STAFF REPORT

HEARING DATE: April 5, 2022

SUBJECT: H-2021-0096
Aviation Subdivision

Preliminary Plat for 48 building lots (6 single family attached lots, 31 townhome lots, 2 detached single-family, and 9 multi-family lots), 8 common lots, and 1 other lot and a Conditional Use Permit for 36 multi-family units on 9 lots on 9.8 acres in the R-15 zoning district.

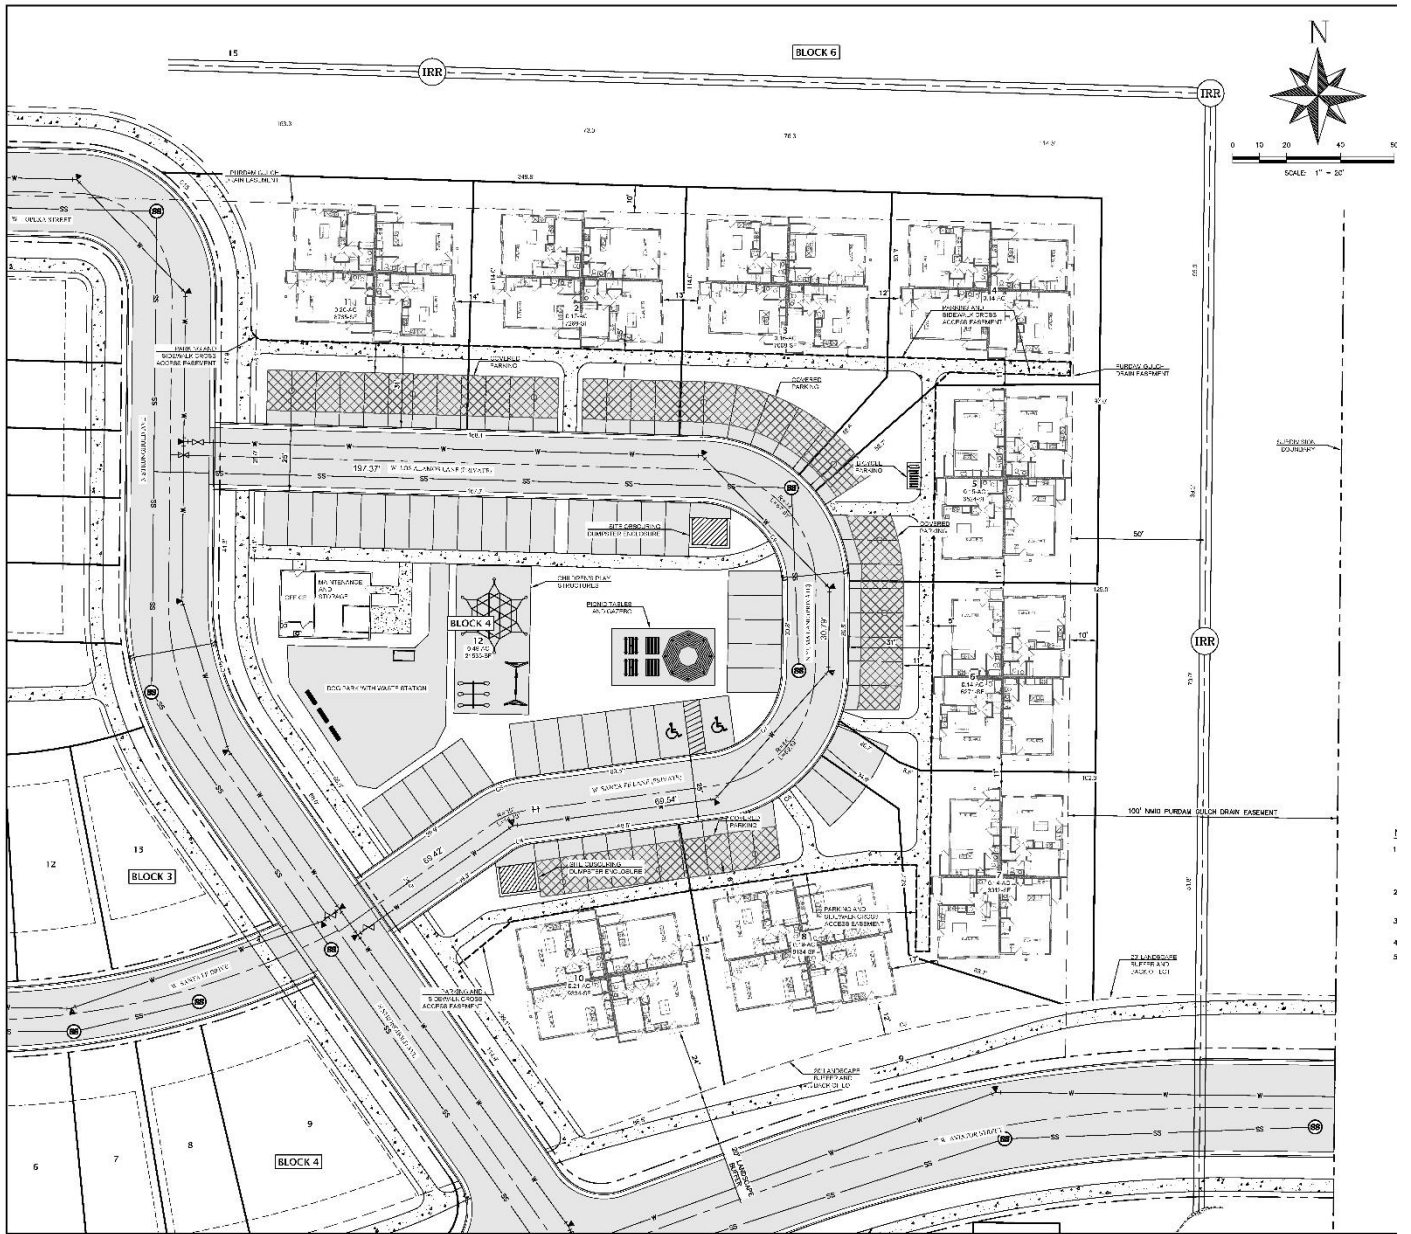
13. The submitted preliminary plat, dated ~~February~~ March 14, 2022, is approved as shown in Exhibit VII.B. shall be revised as follows at least 15 days prior to the Final Plat submittal: City Council hearing noted:

D. CUP Site Plan (March 14, 2022) –

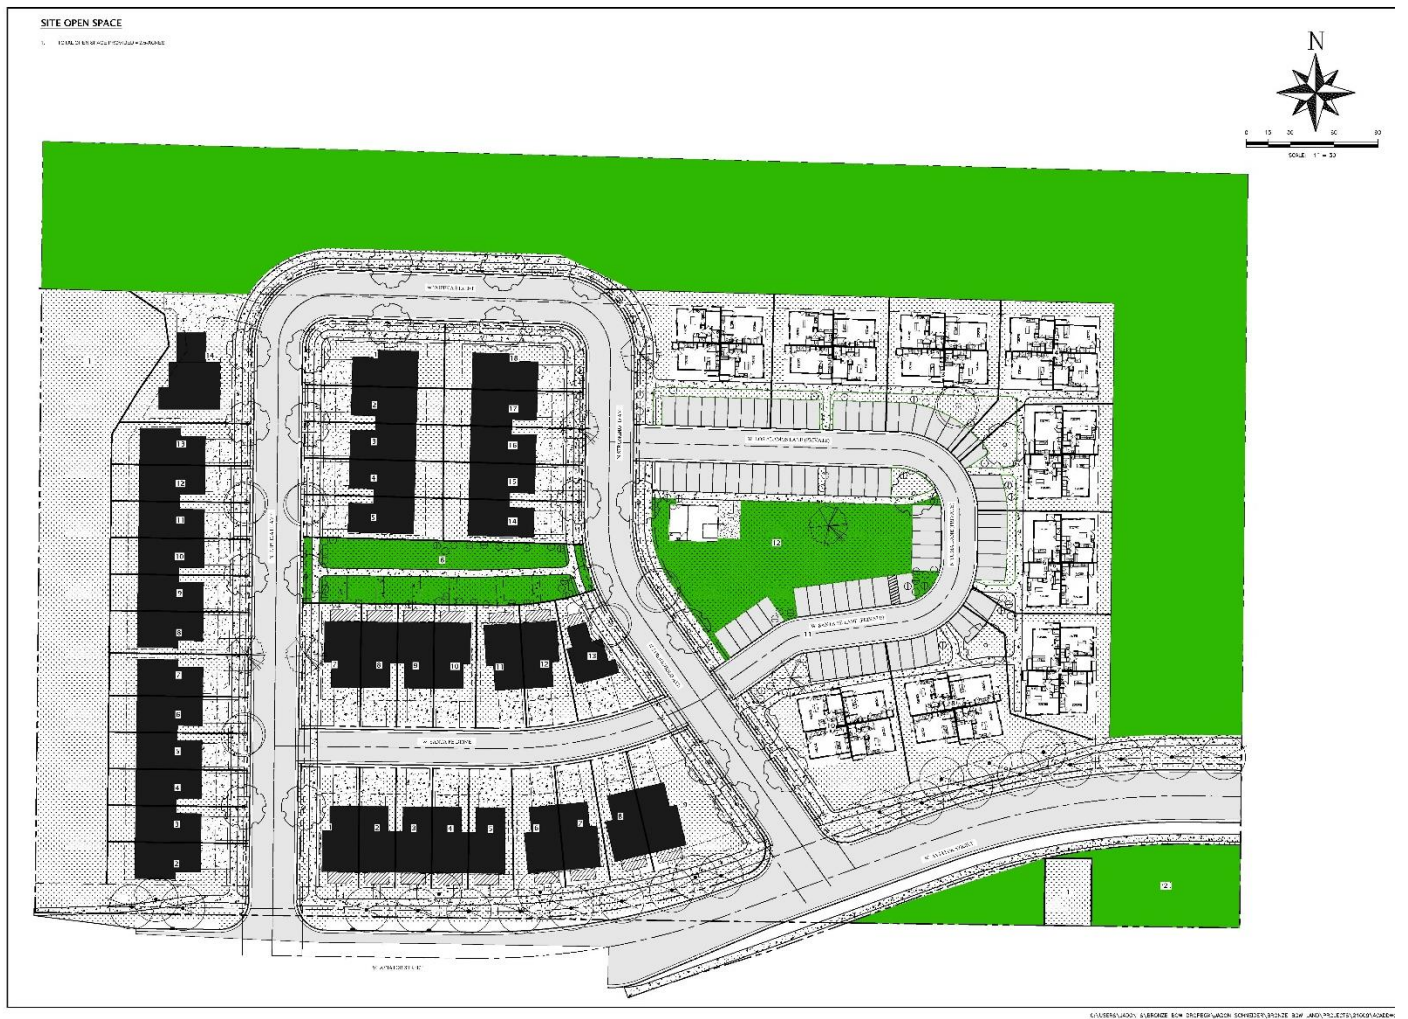
The Applicant is proposing more than 20 units (36 units) so the Applicant is required to comply with these standards. The submitted revised CUP Site Plan does not appear to now show a the required property management office or and a maintenance storage area. Staff is less concerned with the mailbox and directory map location as these items can be easily verified with the future CZC application. However, the Applicant should revise the site plan to show the management office and maintenance storage area prior to the City Council hearing.

16. The submitted CUP Site Plan, dated ~~December 15, 2021~~ March 14, 2022, is approved as shown in Exhibit VII.D with the following standard: ~~shall be revised at least 15 days prior to the City Council hearing prior to Final Plat submittal as follows:~~

- a. ~~Revise the site plan to show the management office and maintenance storage area as required by the multi-family development specific use standards.~~

- b. ~~Clearly depict the building footprint of each 4-plex multi-family building and show the required 10-foot setback between buildings.~~
 - c. ~~Add at least two (2) additional amenities for the multi-family project and clearly depict their locations on the site plan.~~

F. Conceptual Building Elevations and floor plans (dated: March 2022) (~~NOT APPROVED~~)

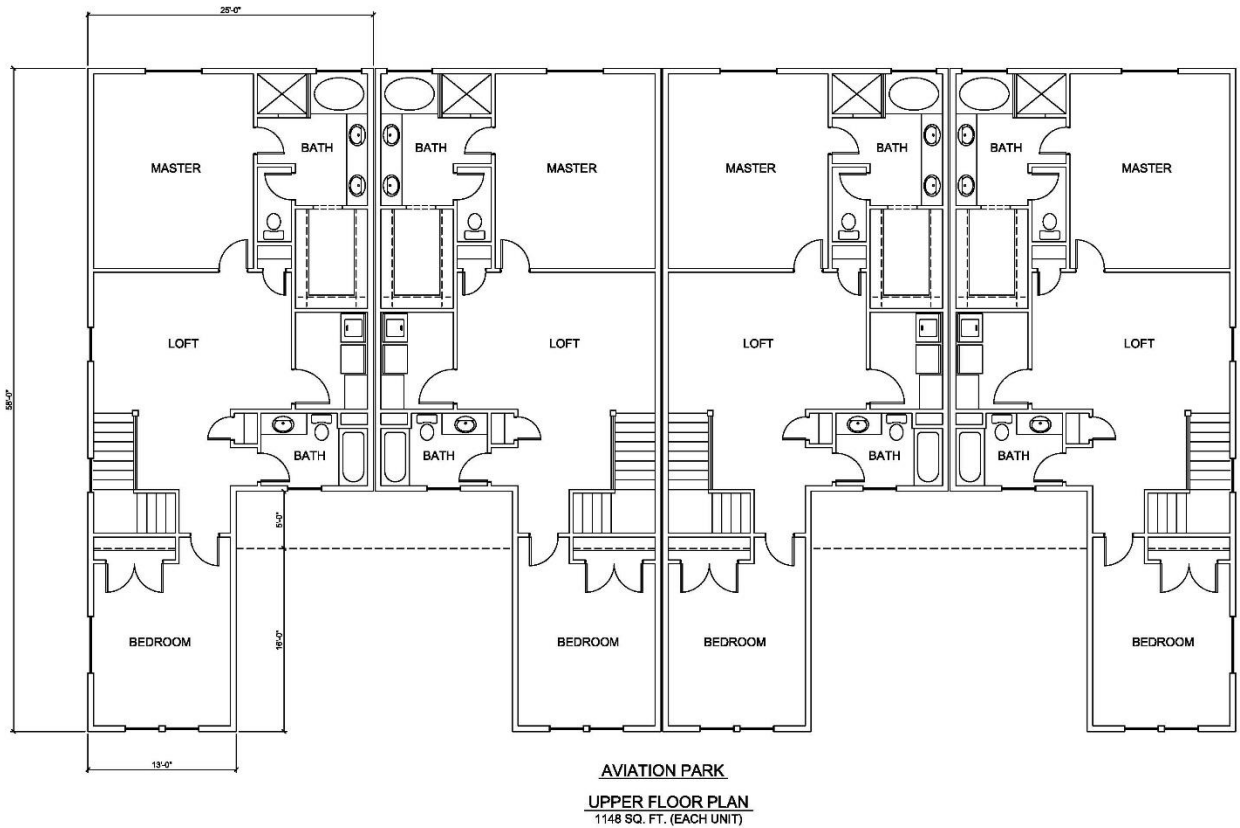
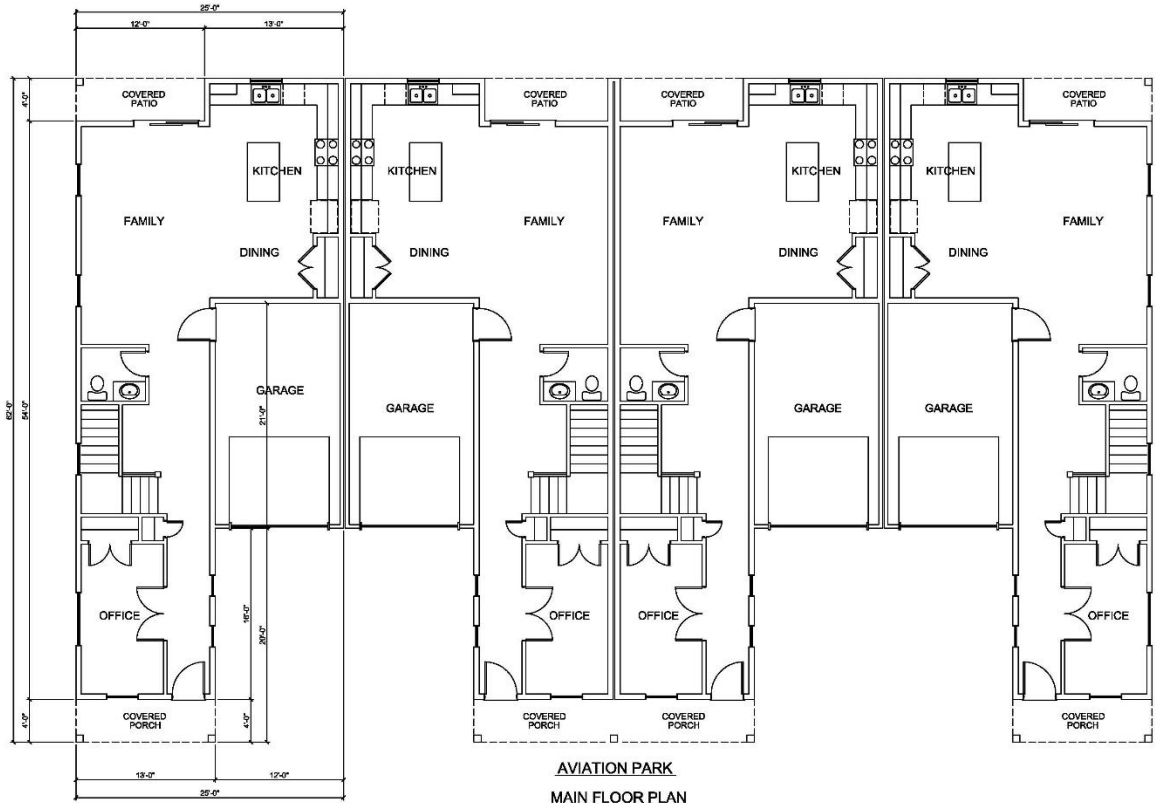
Conceptual building elevations were submitted for the proposed 2-story townhome structures and the multi-family 4-plex buildings as shown in Section VII.F; conceptual elevations for the single-family attached units and the two detached units were not submitted. See additional analysis in the Comprehensive Plan section above (Section V.A). The conceptual building elevations for the townhomes do not list specific materials but appear to show a combination of stone and stucco field materials. The conceptual elevations for the 4-plex units depict varying designs of board & batten siding with stone accents. As noted above in Section V.A, ~~Staff is recommending~~ the Applicant made changes to the front-loaded townhome units in order to better comply with the Ten Mile Plan. In addition to those ~~recommendations~~ changes, Staff is also recommending the Applicant provide modulation in the building placement for the townhome buildings, especially those along the west boundary, to ensure the building wall-plane is not a monotonous wall of garages.

15. The submitted conceptual elevations for the townhome and single-family attached units are approved with the following standards to be maintained: ~~shall be revised as follows at least ten (10) days prior to the City Council hearing:~~

- a. Applicant shall comply with the design guidelines within the TMISAP.
 - ~~b. Explore alternate design options to be more consistent with the street oriented design standards within the Ten Mile Plan while maintaining a gross density of at least 8 units per acre; an alternate floor plan and revised elevations should be submitted in accord with this provision.~~

- c. ~~Revise the elevations to correspond~~ Ensure the street level and upper level architectural detailing ~~to unify is unified throughout~~ the design.

- ~~d. Provide additional modulation in wall plan and roof height variation.~~
 - e. Depict varying build-to lines for all of the front-loaded townhomes to ensure modulation in the building massing between and along sets of the townhome buildings.
